Cyprus Plateau Mining Corporation
P.O. Drawer PMC
Price, Utah 84501
(801) 637-2875

October 15, 1993

RE: GENTRY RIDGE GROUND WATER DRAWDOWN CONCERN

Gentry Ridge Ground Water Elevation Change As Mining Progresses

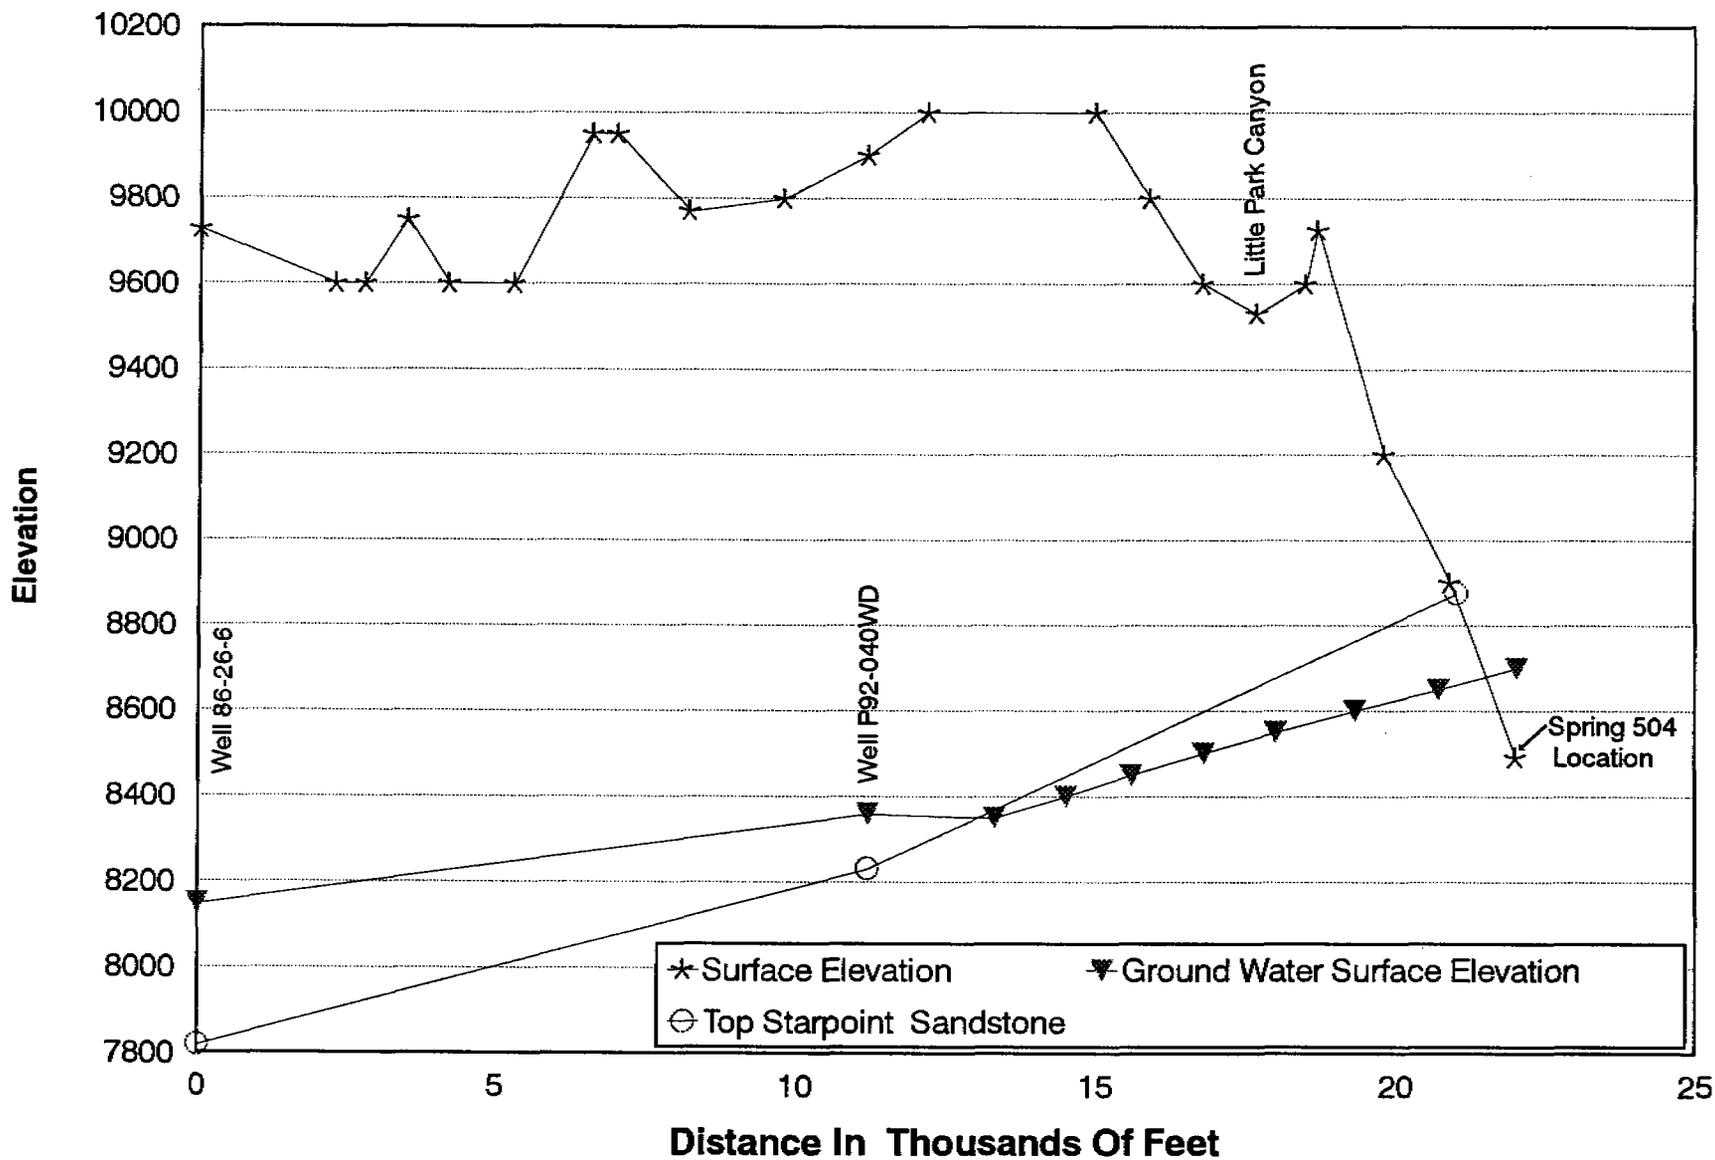
The attached graph titled Gentry Ridge Ground Water Elevation Change As Mining Progresses shows the average water elevation in underground monitoring wells P92-01C-WD, P92-02-WD, and P92-04-WD in relationship to the average elevation of the mine face (or active mining area) as mining progresses downdip to the south in Gentry Ridge. It is interesting to note that since About August of 1992, the water level has followed the same general trend as the mine elevation. This may indicate a leveling off of dewatering, and that the maximum expected volume of water flowing into the mine has been reached, and that recharge to the area equals dewatering. The average discharge volume from the Gentry Ridge area, as measured by a flow meter, has shown an increase of only about 10 to 15 GPM over the past 4 months. This may confirm that the maximum expected volume of water flowing into the mine has been reached, and that recharge now approximately equals discharge. In addition, this graph may indicate that the water table will not be drawn down more than approximately 110 feet.
